Steering and Suspension: All Technical Service Bulletins Steering Wheel Oscillation/Vibration With EVO Steering

Bulletin: 92-3-21

SUBJECT:
STEERING WHEEL OSCILLATION/VIBRATION (NEW STEERING DAMPER)

MODELS AFFECTED:
1992 ROADMASTERS WITH EVO STEERING (RPO NV7)

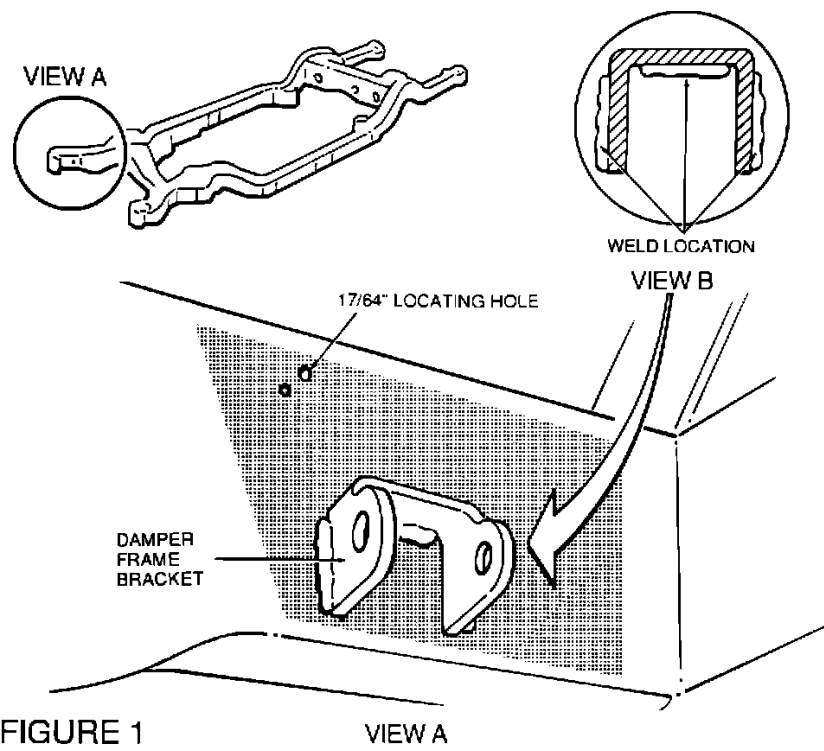
Some 1992 Roadmasters with variable effort Power Steering (RPO NV7), may exhibit a slight steering wheel oscillation/vibration apparent when operated over irregular/rough road surfaces.

Reduced power assist requirements result in greater road feel inputs being transmitted through the steering system.

Install a steering damper and required attaching components noted in the service procedure as indicated.

3. Referring to Figure 1, locate approximate area where damper bracket is to be welded to R.H. inner frame rail. Clean area with GM Tar and Road Oil Remover, P/N 1050172, or equivalent, insuring all dirt and wax coating is removed.

and 75 percent argon 25 percent CO2 gas. Refer to Figure 1 for proper weld bead location.
